NOVI ACRES JSP 25-0012

Public hearing at the request of Cypress Partners, LLC for recommendation to the City Council for Amendment of the Consent Judgment that governs development of the property. The applicant is proposing a 61-unit multi-family residential development, a standalone retail building, and associated parking.

3rd Revised Site Plan and Request to Amend Consent Judgment

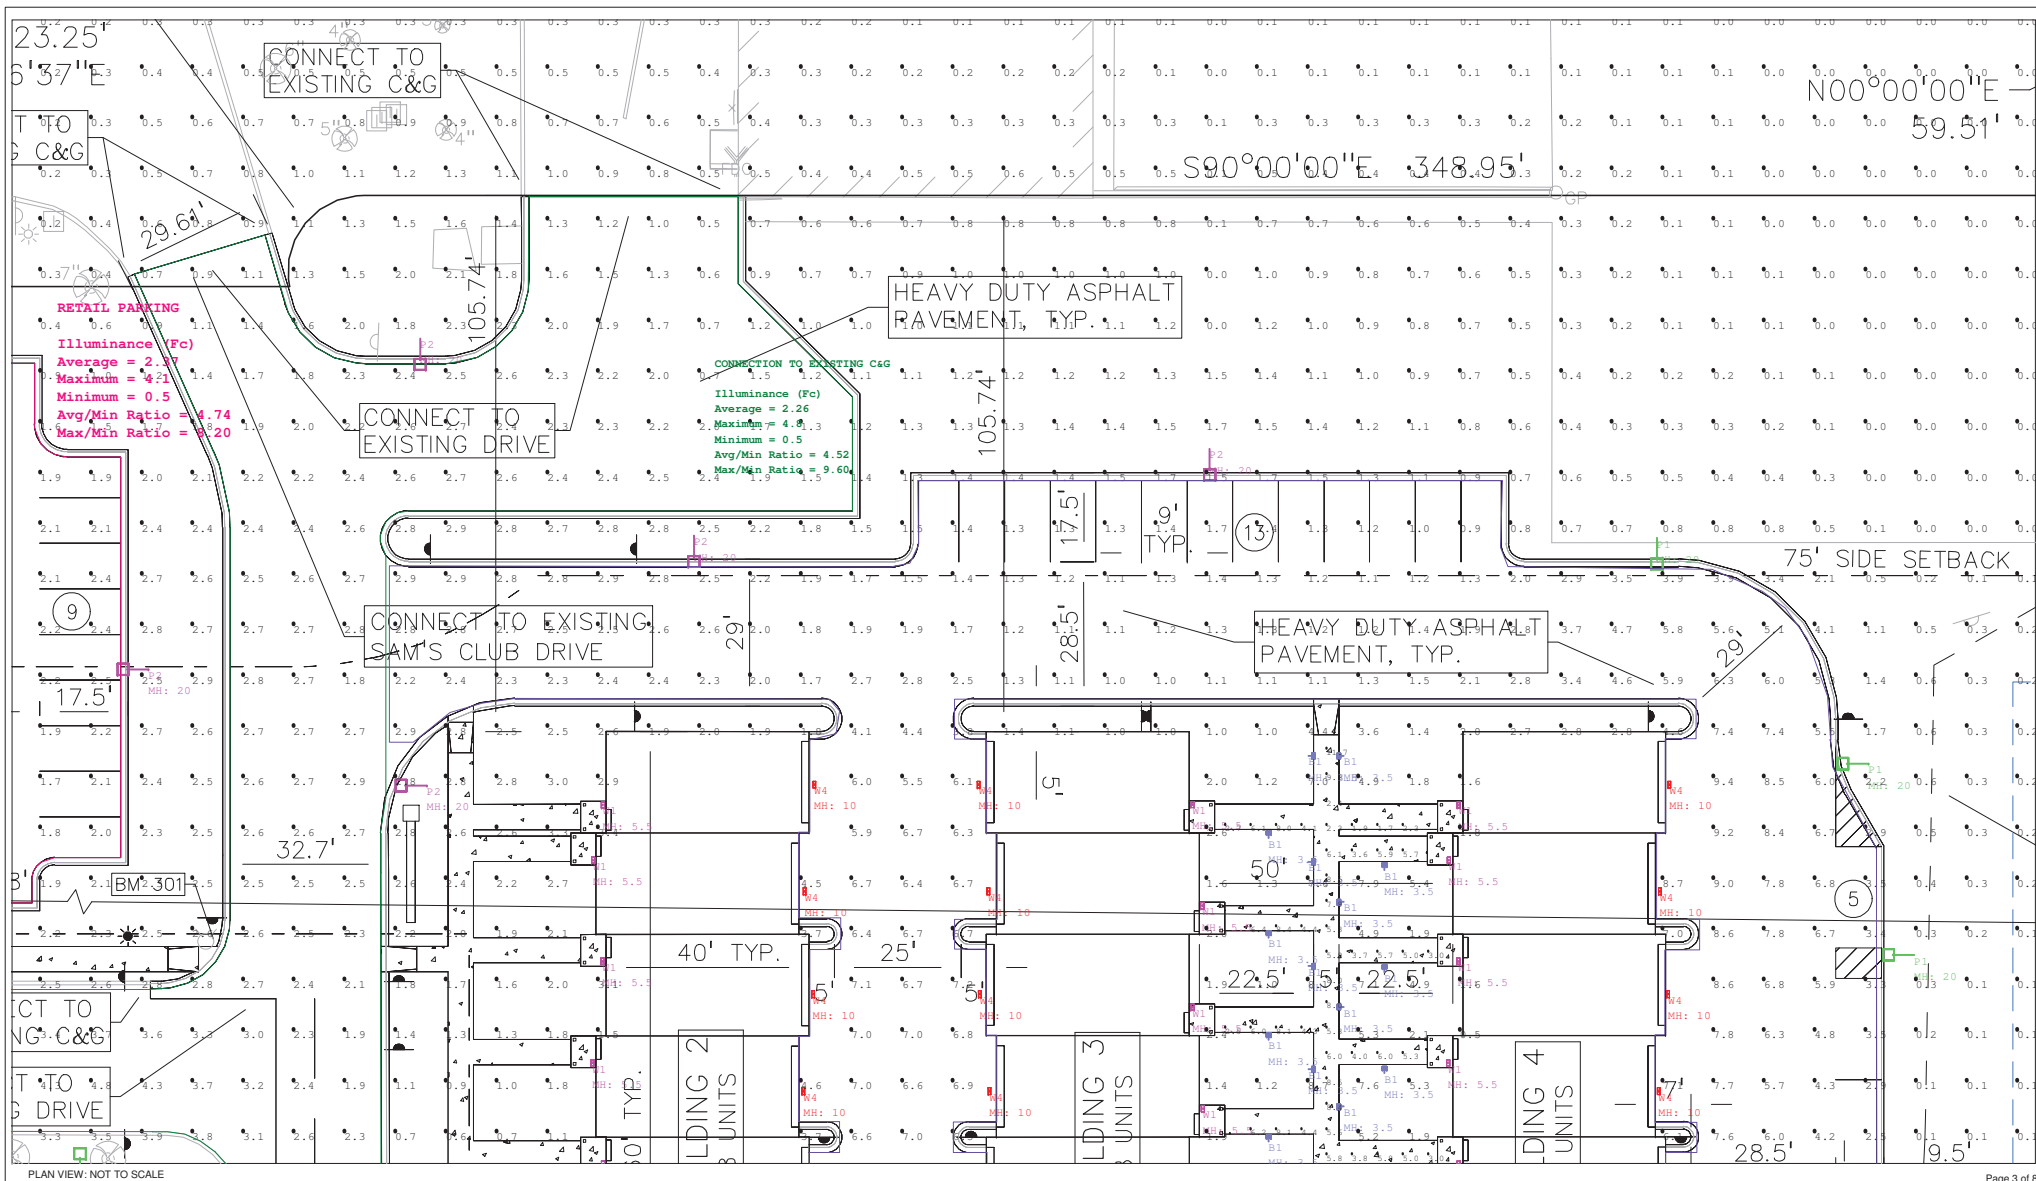
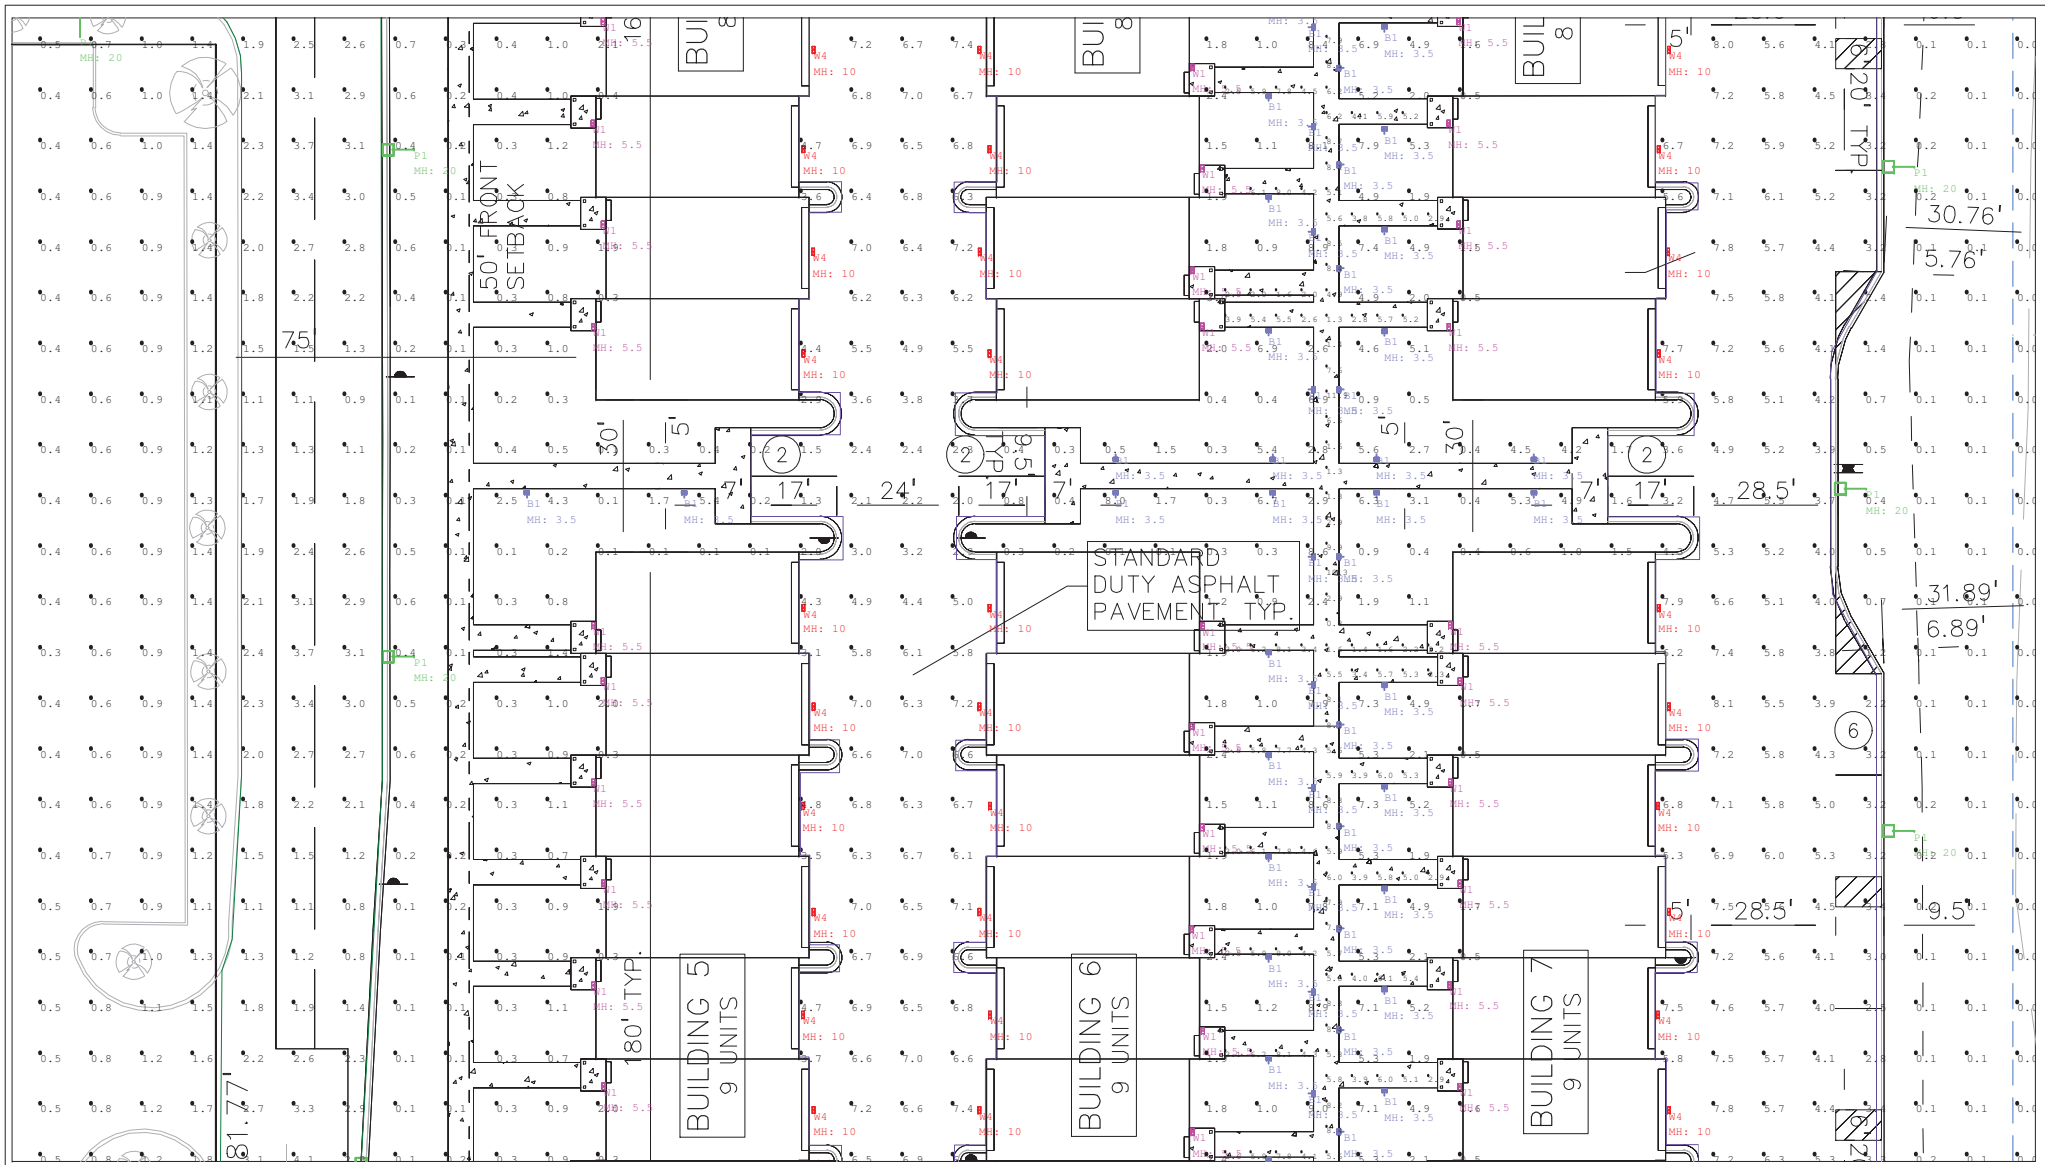
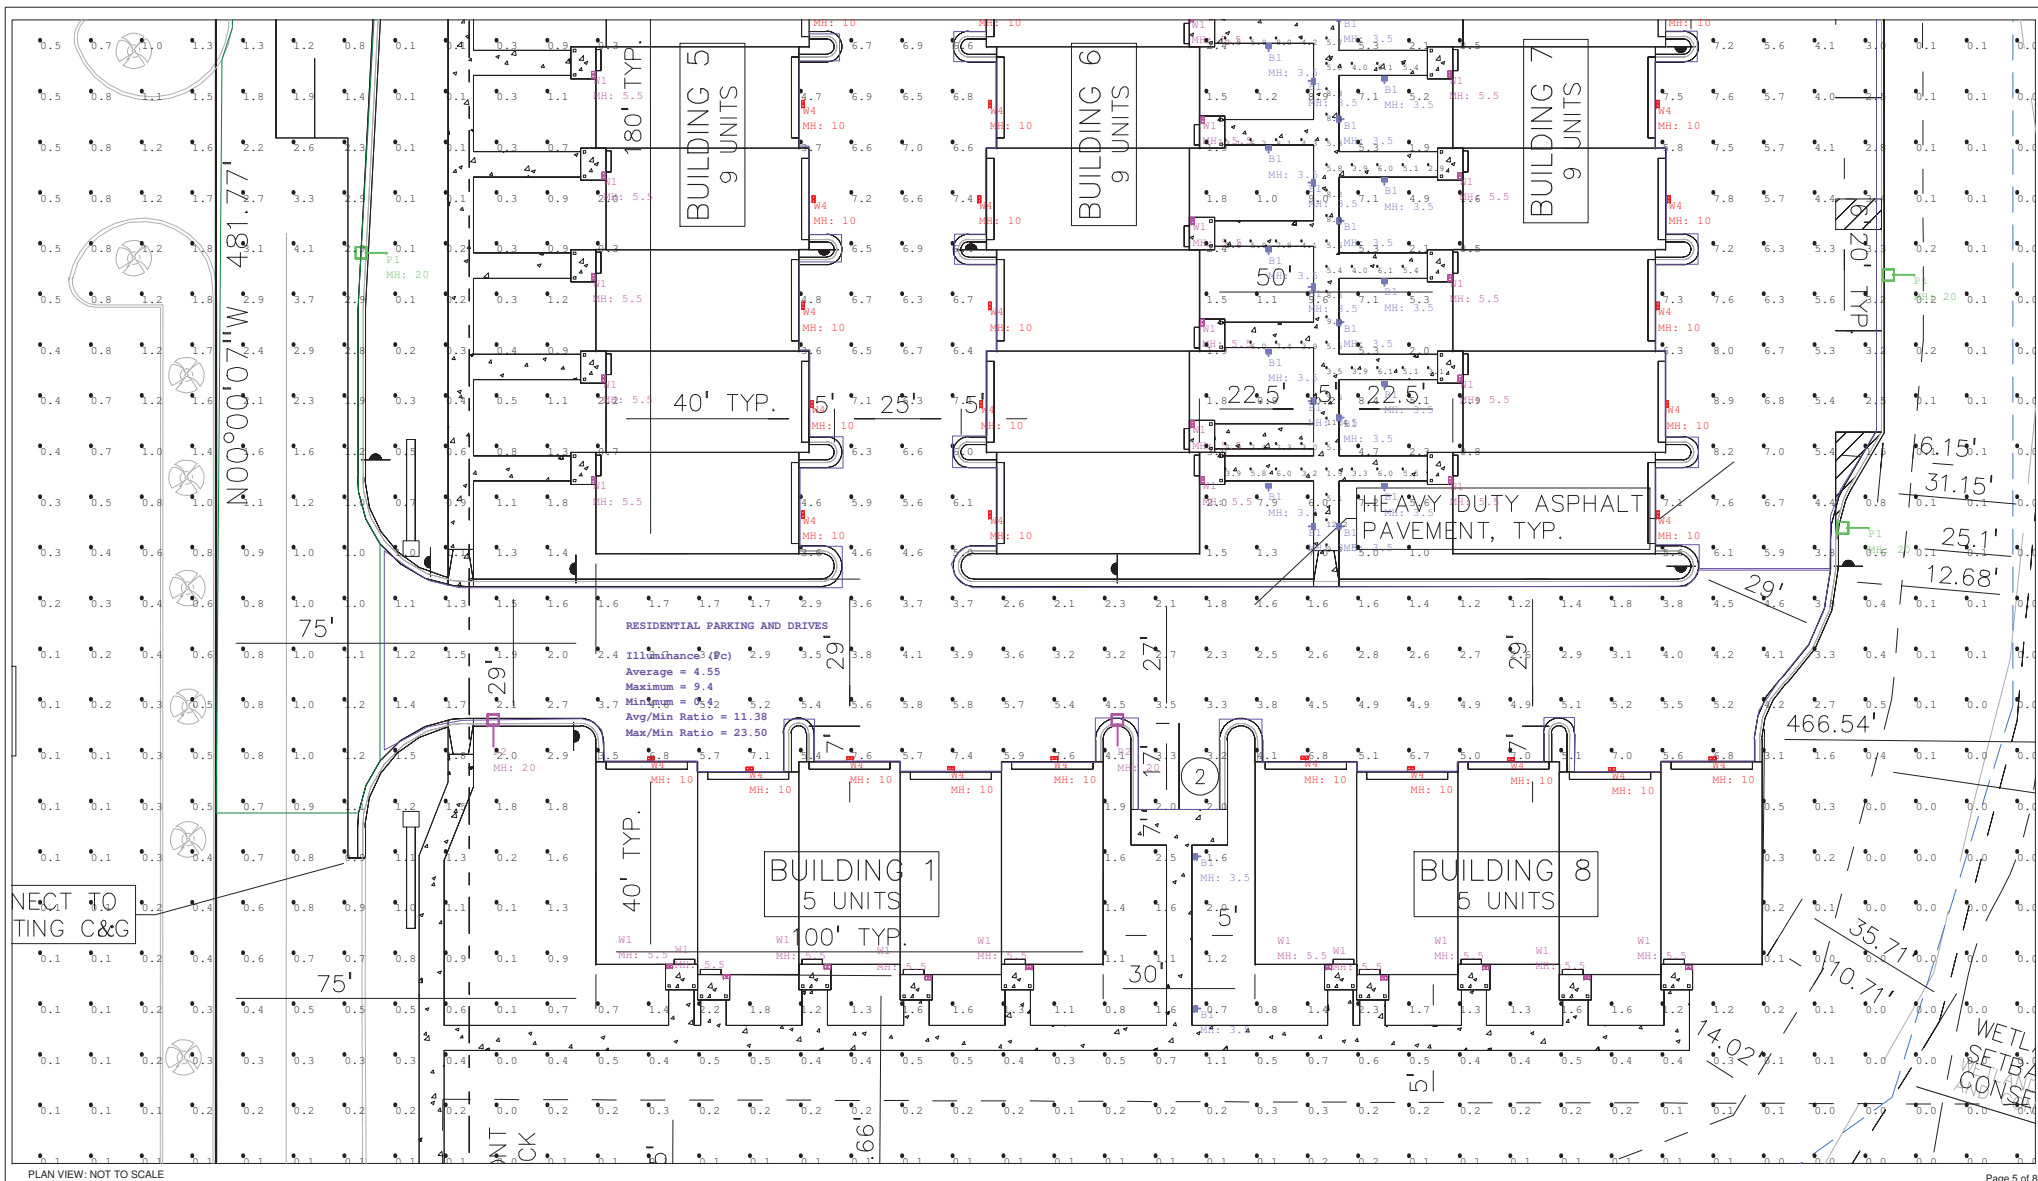
Relevant building elevation drawings showing all fixtures, the portions of the walls to be illuminated, illuminance levels of walls and the aiming points of any remote fixtures. **Please provide light levels on building facades, if information is provided at the time of final site plan, they are expected to comply. Any deviations at that time would require amendment to consent judgment.**

Attached are lighting photometric sheets which show the average lighting in compliance with city ordinances.
